SUMMARY MEETING MINUTES
DOE/NRC MEETING
BWIP HYDROLOGY PROGRAM
MAY 22, 1985
SILVER SPRING, MARYLAND

The NRC staff presented (Attachment 8) comments received in response to the December 1983 publication of Draft Technical Position 1.1 "Hydrogeologic Testing Strategy for the BWIP Site." Further information was presented on NRC statistical work of BWIP hydrochemistry data.

Both the NRC and DOE presented opinions and positions concerning the intent and definition of "consensus baseline" as identified in the Draft STP 1.1 logic diagram for BWIP Hydrology Test Strategy Stage 1 decision point. These opinions and positions plus general comments are detailed in Attachment 3 for DOE and Attachment 4 for the NRC staff.

LOGIC DIAGRAM FOR BWIP HYDROLOGIC TEST STRATEGY ^①

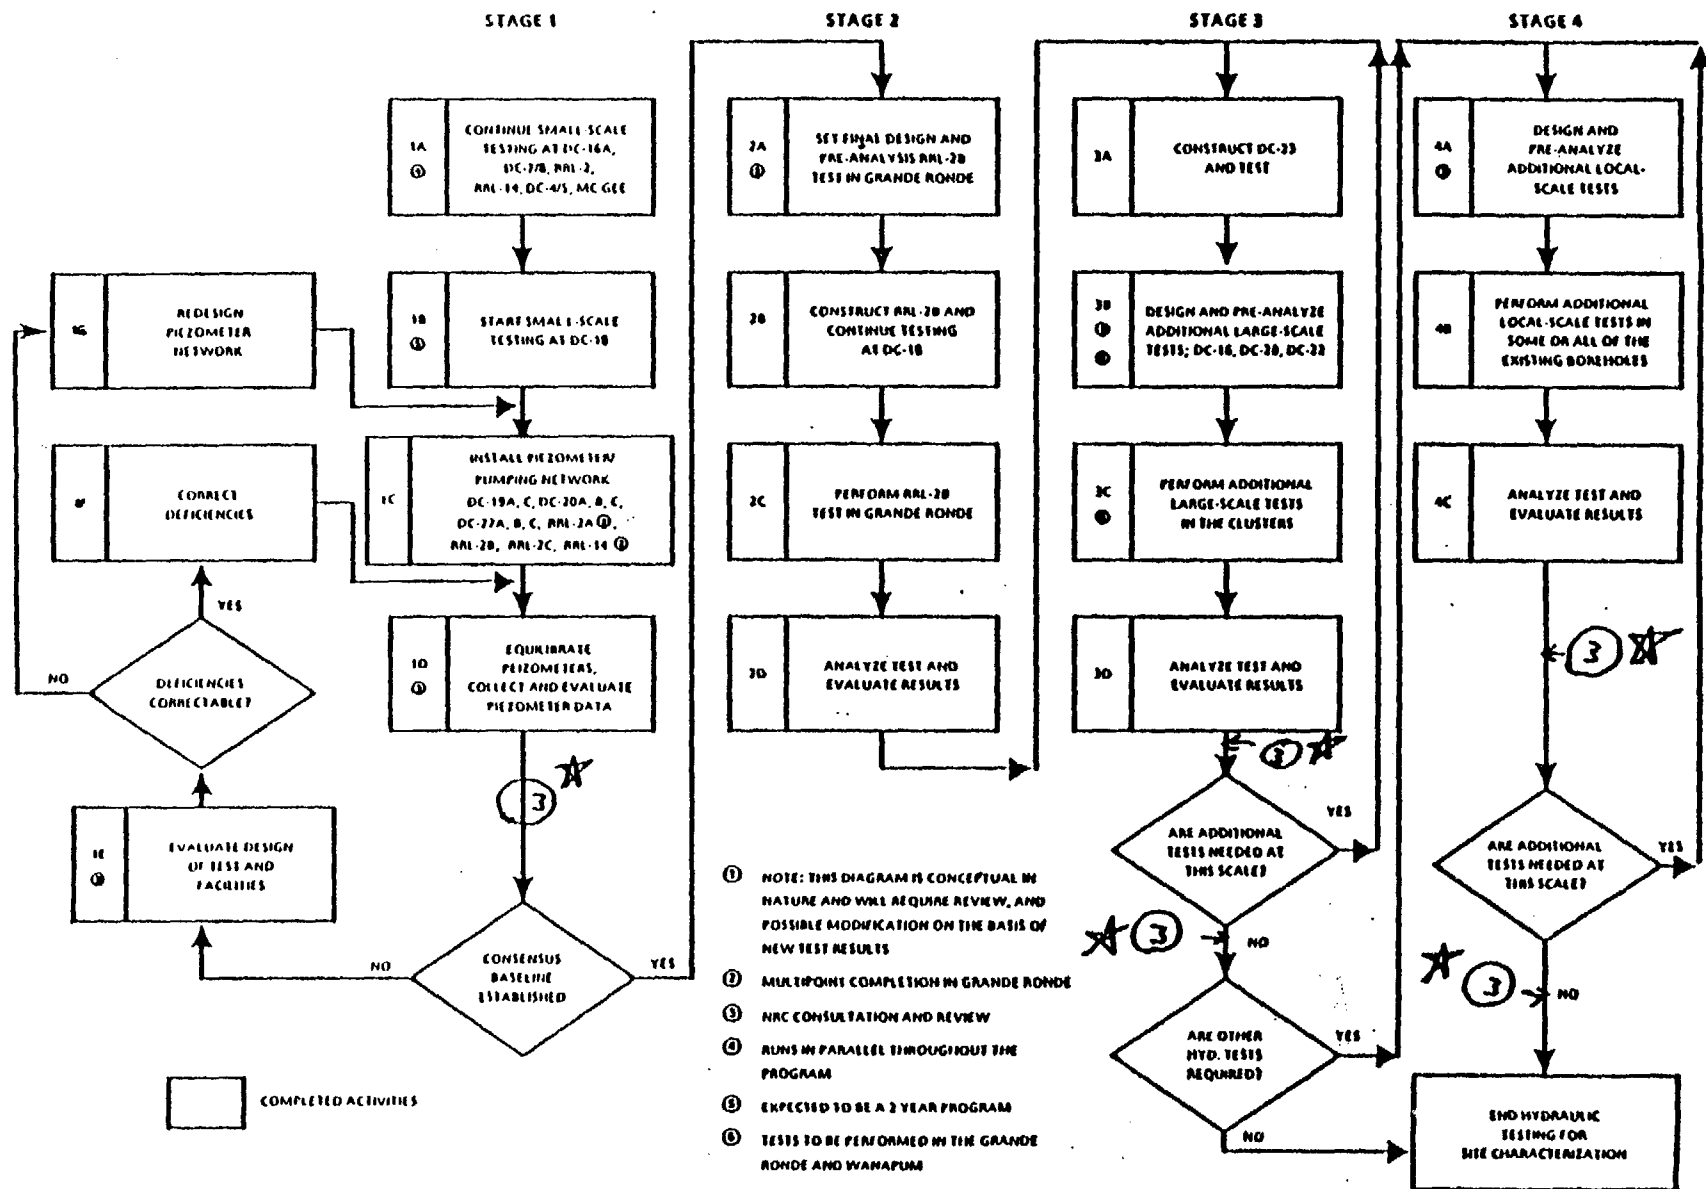
NRC and DOE have agreed on the reinstatement of NRC consultation and review in the logic diagram for the hydrologic testing program as shown on the attached "Logic Diagram," presented by DOE at the December 1983 hydrology meeting as well as this meeting. These consultations appear prior to all of the major decisions and planning points in the figure.

★ changes agreed to by NRC and DOE
at conclusion of May 85 hydrology meeting with respect to
"NRC consultation and review" points only.

WATER-LEVEL HYDROGRAPHS DC-22 MULTI-LEVEL PIEZOMETER FACILITY DURING DRILLING OF RRL-2C

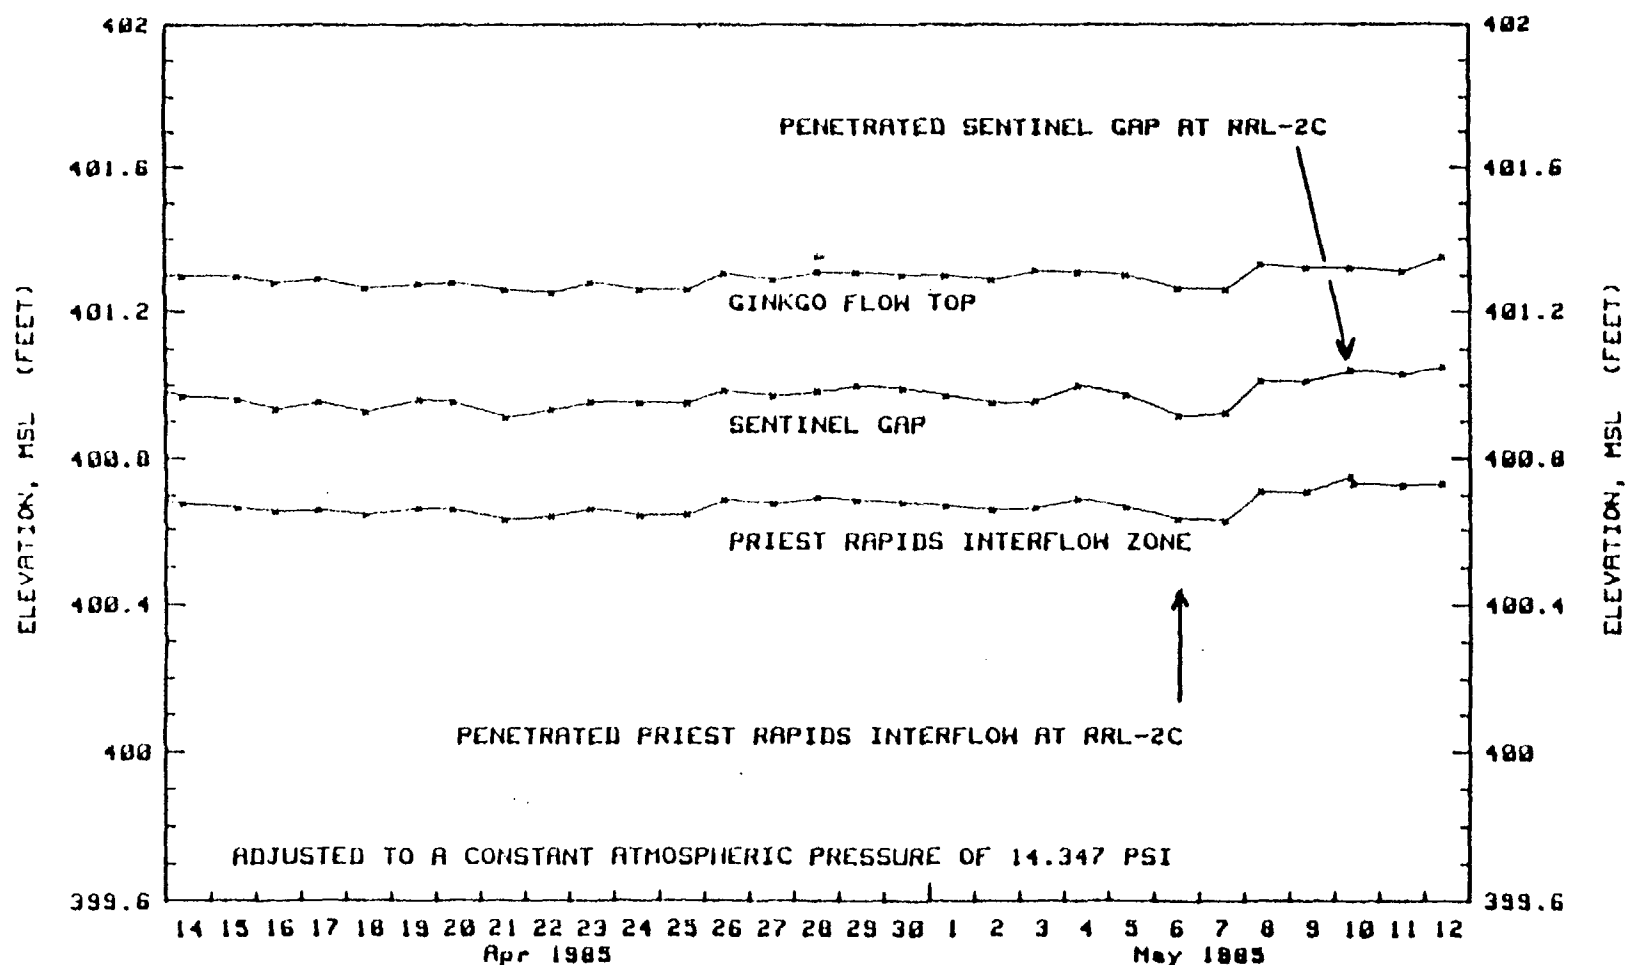
The data being collected at DC-19, DC-20, and DC-22 are useful for establishing the head trends at these locations. Based on the data reviewed by NRC up to this time, which is data from 1984, we note that the Grande Ronde water levels appear to remain in a state of transience. Until we obtain and review the monitoring data from January to the present we cannot provide any statement regarding the ability to extrapolate the head trends at these locations. Extrapolation of head trends is necessary for LHS test data analysis at these locations and to infer static heads to define the flow system. The NRC requests that we be provided with the analyses cited by DOE during the workshop in order to review and provide comment on the adequacy of the baseline in terms of interpretability of the LHS tests. The NRC also will need to examine data collected during the drilling of RRL-2C to evaluate the potential perturbations to the baseline caused by the drilling.

- ° DOE plans to provide information to substantiate schedule changes in LHS Testing at Hanford.
- ° DOE commits to provide NRC an up-to-date piezometric data set for DC-19, DC-20, and DC-22, standardized to remove barometric effects within two weeks.
- ° NRC will review the changes identified in item 4, and intends to provide comments to DOE within a month.
- ° NRC requests updates on the monitoring data from other on-site wells (data collected subsequent to September 1984).
- ° NRC requests that DOE provide the analyses cited by DOE during the workshop supporting their position that the baseline is adequate for interpretation of planned hydraulic tests.
- ° NRC requests that DOE provide data collected from neighboring boreholes during drilling of RRL-C2 to evaluate potential perturbations to the baseline caused by the drilling.
